2022/1403/P - Flat D, 31 Lancaster Grove, NW3 4EX

Delegat	ed Re	port ^A	Analysis sheet		Expiry Date:	27/05/2022	
(Members Briefing)			'A / attached		Consultation Expiry Date:	29/05/2022	
Officer				Арр	lication Numbe	r(s)	
Miriam Baptist					2022/1403/P		
Application Address					Drawing Numbers		
Flat D 31 Lancaster Grove Camden NW3 4EX				See draft decision notice			
PO 3/4	Area Tea	m Signature	C&UD	Auth	norised Officer	Signature	
Proposal(s)							
Dormer extension to front facade, solar panels and skylight to flat roof, and replacement bi-folding doors to existing rear terrace.							
Recommendation:		Grant conditional planning permission					
Application Type:		Full Planning Permission

Planning permission is sought for a dormer extension to front roofslope, solar panels and skylight to flat roof and replacement bi-folding doors to existing rear dormer.

Photo 7 (above): Revised proposed dormer (with previously proposed in dashed lines)

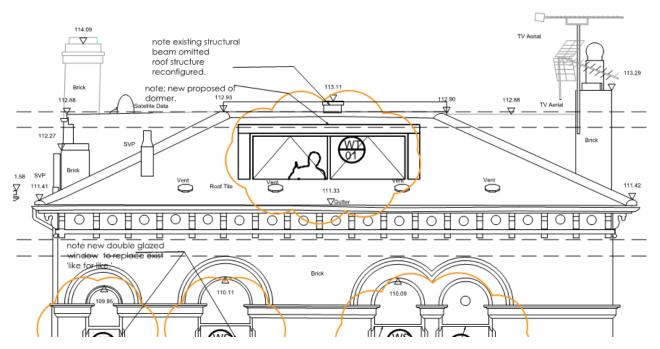
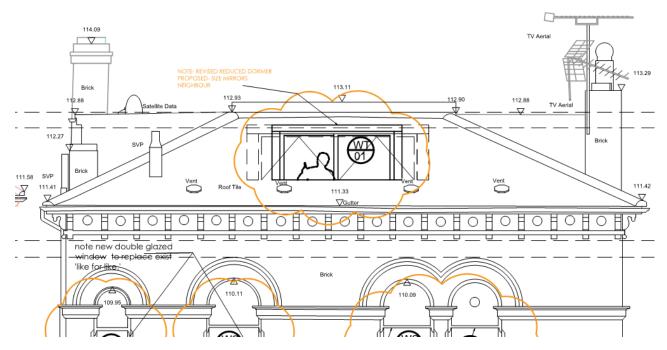
Belsize CAAC:	 An objection was received by the CAAC which can be summarised as follows: Object to skylight Object to the dormer which is excessively large and out of scale with the building. Object to the metal bi-fold doors. Object to the new AC unit. Officer's response: The rooflight has been reduced in area by 50%. The dormer has been reduced in width to by in-keeping with the existing dormers on the street. Please see section 2.4 of the report below. The air-conditioning unit has now been omitted from the scheme.

1.2. The proposal has been revised in response to officer concerns and neighbour objections. Initially the application included an AC conditioning unit which has now been omitted, a larger rooflight which has been reduced in size, and a wider front dormer extension which has been reduced.

- 2.2. Camden Planning Guidance (CPG) on Home Improvements states that roof extensions should consider the existing overall roof form, any impact in key views and be proportionate to the roofslope being extended. In terms of dormers specifically, it states that the design should emphasise the glazing element and the solid structure should complement this in a form and scale appropriate to the roof being extended. Roof dormers should sit within the roof slope and appear as an extension to the existing roof whilst the existing roof form is maintained. The proposed dormer is considered to meet this criteria.

- 2.3. Modest dormer windows are not an unusual feature along Lancaster Grove, they protrude above the shallow roof pitches and tend to be fairly compact and upright in proportion. Due to the position of the host property on Lancaster Grove, it can be viewed from Strathray Gardens. However, due to the proportions of the dormer, it would be in line with the existing dormer to the neighbouring property and would not be read as an incongruous addition. The revised dormer is considered to be in line with this existing pattern of development, and the CPG guidance referred to above, and therefore is not considered to be of harm to the host property, street and the wider conservation area.
